California High-Speed Rail Authority

# *Burbank to Los Angeles*

**Final Environmental Impact Report/  
Environmental Impact Statement**

**Appendix 3.1-C: Evaluation of Engineering  
and Design Refinements since the  
Publication of the Draft EIR/EIS**

Group #8 - Utility Relocations

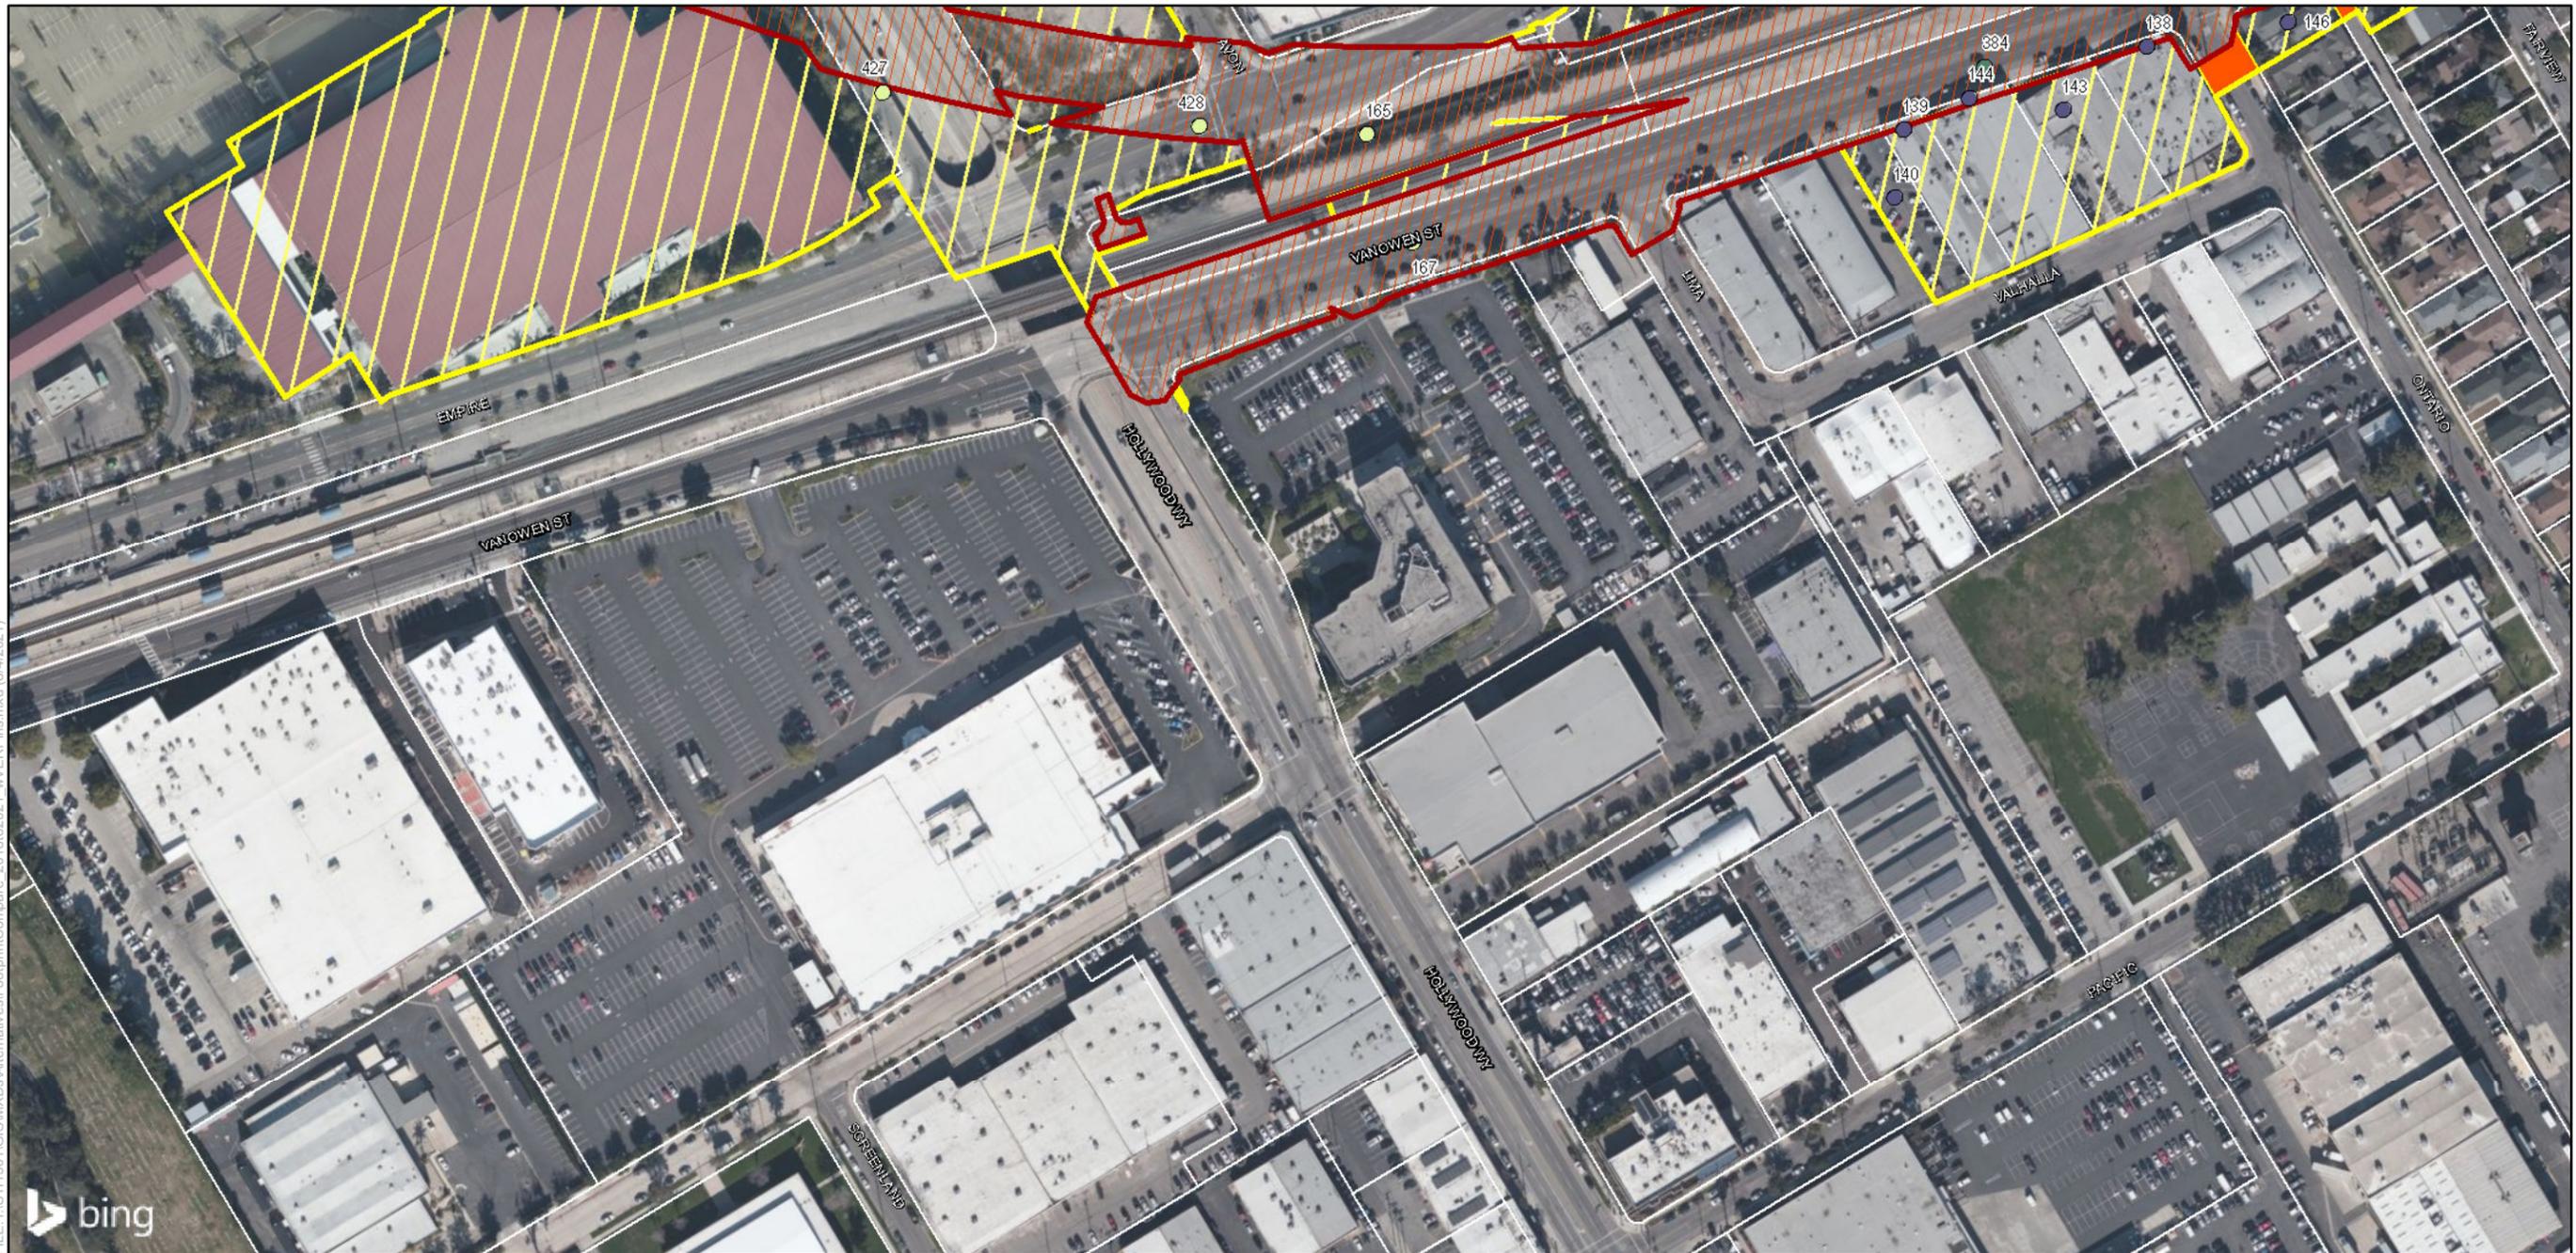
183	3690+26	SB	N/A	Design refinement for dedicated utility easement needed for relocated fiber, sewer, water, gas, and electrical lines to avoid conflict with roadway overpass retaining wall construction.	N/A	Design refinement is within the environmental footprint analyzed in the Draft EIR/EIS released for public review on May 29, 2020.
362	3686+77	SB	N/A	Design refinement in response to stakeholder coordination to guarantee access to an unobstructed facility/parcel during HSR construction.	N/A	A portion of footprint addition is outside of the 2019 APE boundary and was added to the APE boundary updated in the APE modification memorandums (2021)
184	3688+24	SB	N/A	Design refinement for dedicated utility easement needed for relocated fiber, sewer, water, gas, and electrical lines to avoid conflict with roadway overpass retaining wall construction.	N/A	Design refinement is within the environmental footprint analyzed in the Draft EIR/EIS released for public review on May 29, 2020.

185	3687+04	SB	N/A	Design refinement for dedicated utility easement needed for relocated fiber, sewer, water, gas, and electrical lines to avoid conflict with roadway overpass retaining wall construction.	N/A	Design refinement is within the environmental footprint analyzed in the Draft EIR/EIS released for public review on May 29, 2020.
186	3685+43	SB	Addition	Design refinement in response to stakeholder coordination to guarantee access to an unobstructed facility/parcel during HSR construction.	26,532	A portion of footprint addition is outside of the 2019 APE boundary and was added to the APE boundary updated in the APE modification memorandums (2021)
187	3691+74	SB	Addition	Footprint addition for dedicated utility easement needed for relocated fiber, gas, and electrical lines avoiding conflict with roadway overpass retaining wall construction.	1,111	This footprint addition is within the 2019 APE boundary.

192	3689+73	SB	Addition	Footprint addition needed to support a newly identified utility easement located to the east of Main Street. Utility easement would support the relocated fiber, water, and electrical lines relocated to avoid conflict with the roadway overpass retaining wall construction.	3,159	A portion of footprint addition is outside of the 2019 APE boundary and was added to the APE boundary updated in the APE modification memorandums (2021)
196	3686+53	NB	Addition	Footprint addition to account for the Lamar Street/Main Street connection and construction of roadway on retained fill. Modifications include a relocated access and potential reconfiguration of concrete ready mix facility operations.	20,543	A portion of footprint addition is outside of the 2019 APE boundary and was added to the APE boundary updated in the APE modification memorandums (2021)
199	3684+25	NB	N/A	Design refinement in response to revised roadway design at Main Street and Lamar Street. Impacted parcel is no longer considered an acquisition, but a temporary construction easement.	N/A	Design refinement is within the environmental footprint analyzed in the Draft EIR/EIS released for public review on May 29, 2020.

Group #2 - Chevy Chase Overpass

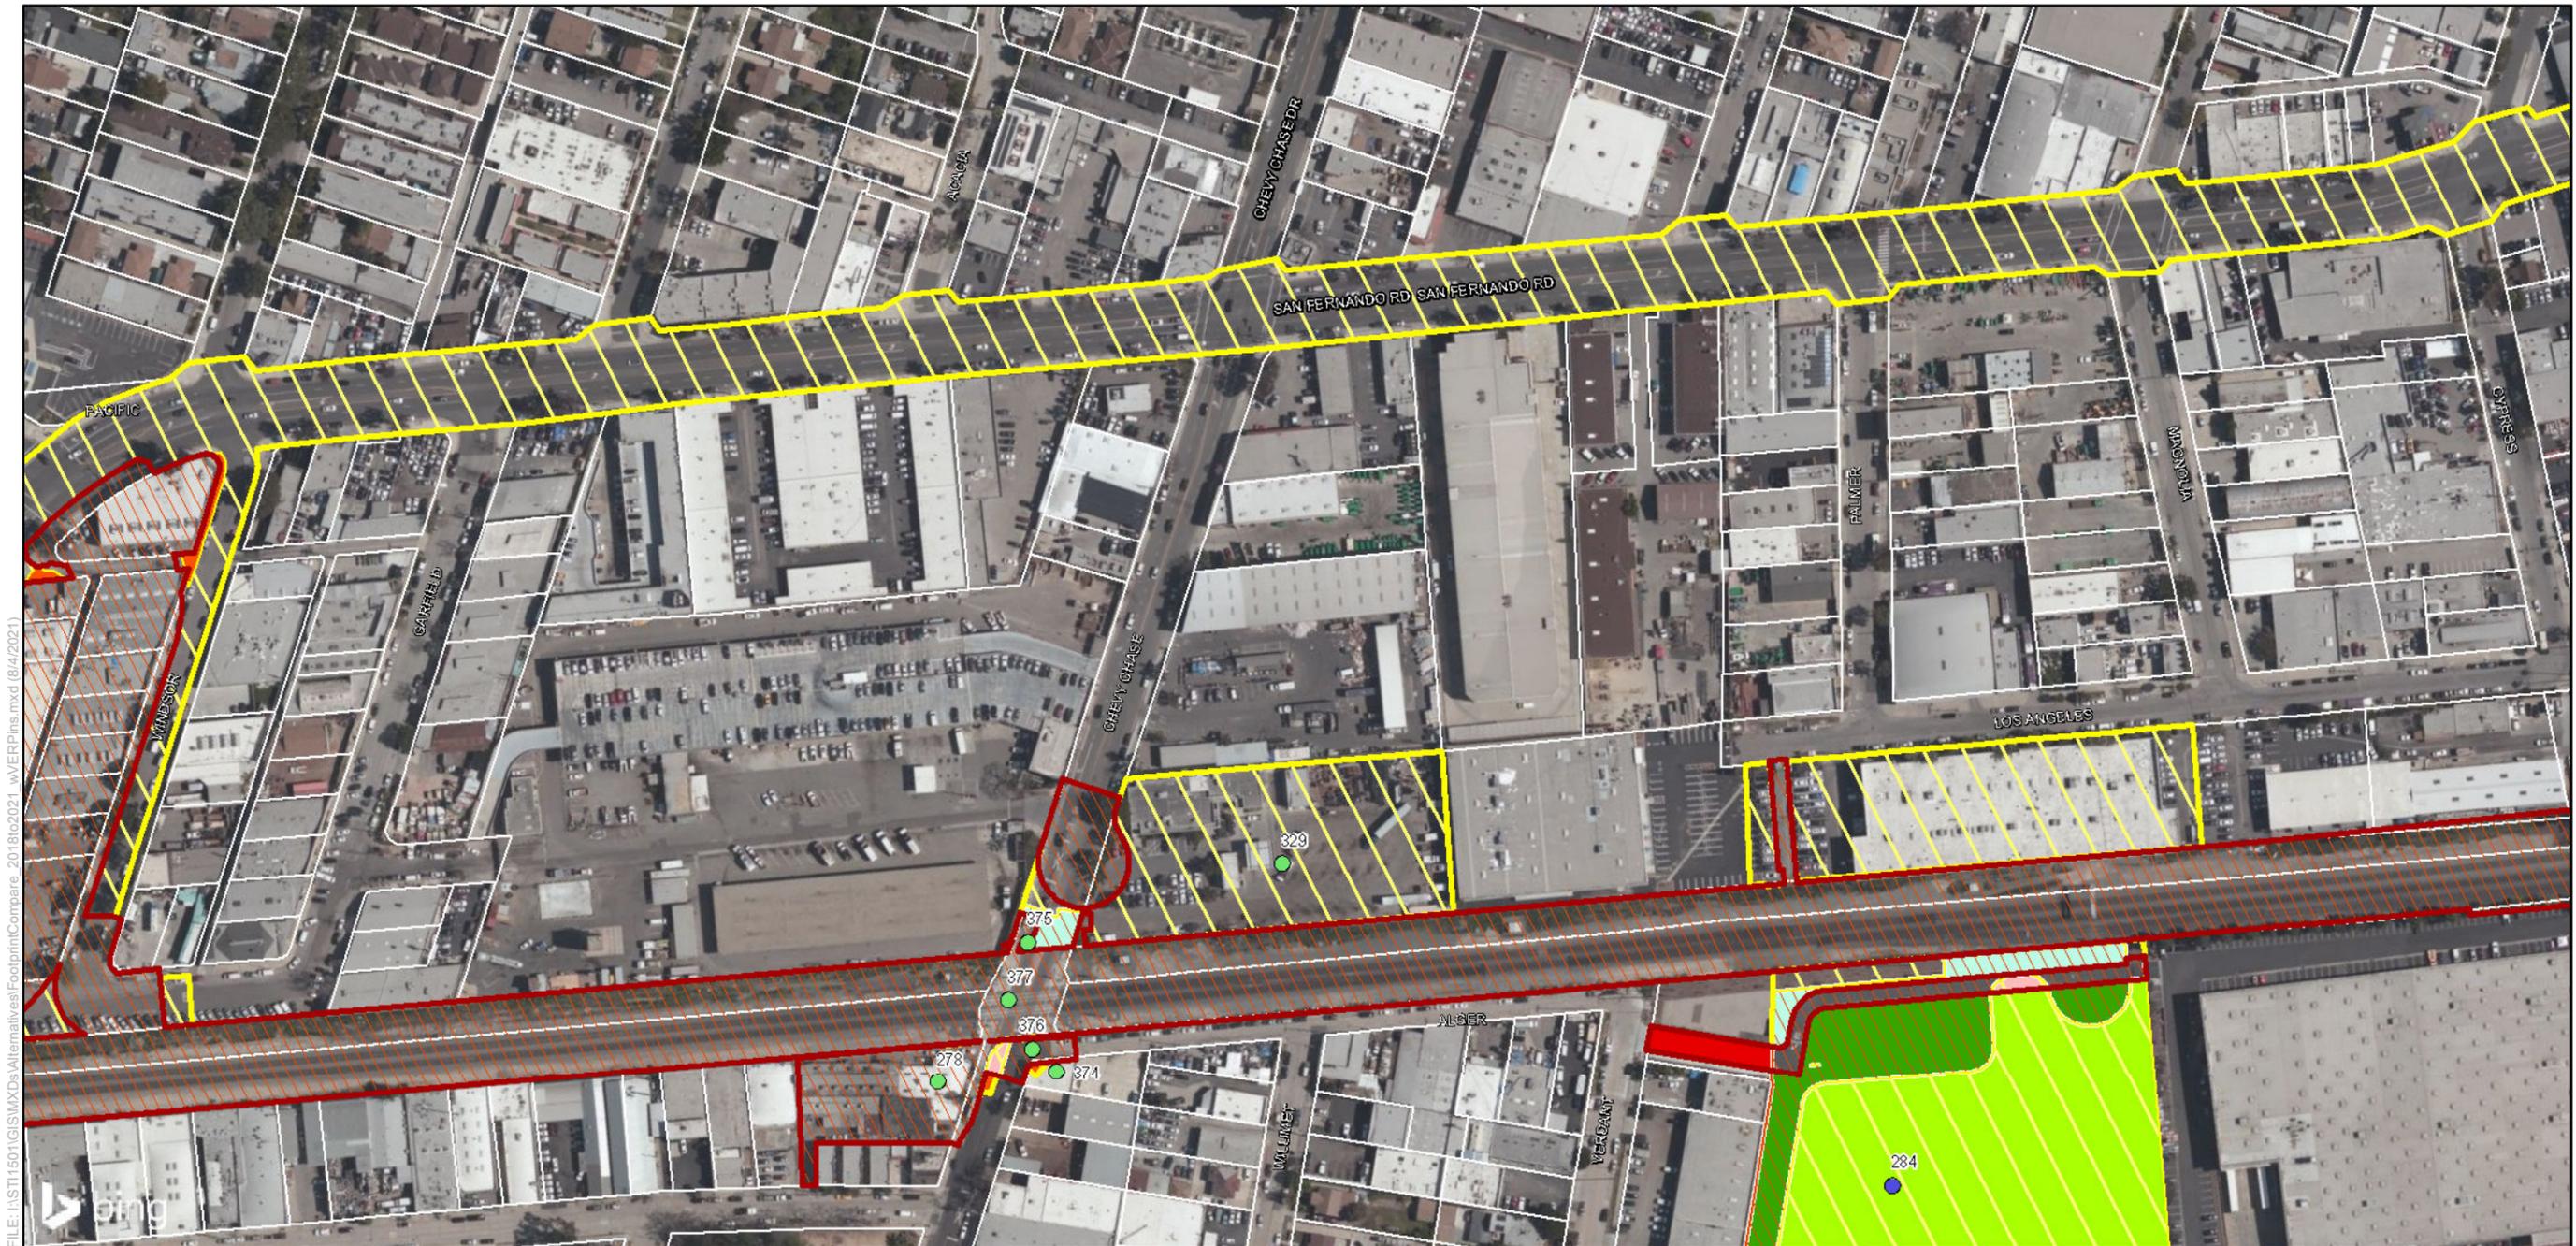
#### **Chevy Chase Drive**

The City of Glendale opposed the closure of Chevy Chase Drive and the conversion of it to a cul-de-sac and the installation of an underground pedestrian passageway. In response to this comment, the pedestrian undercrossing was modified to be a pedestrian overcrossing to address the City's concerns regarding safety.
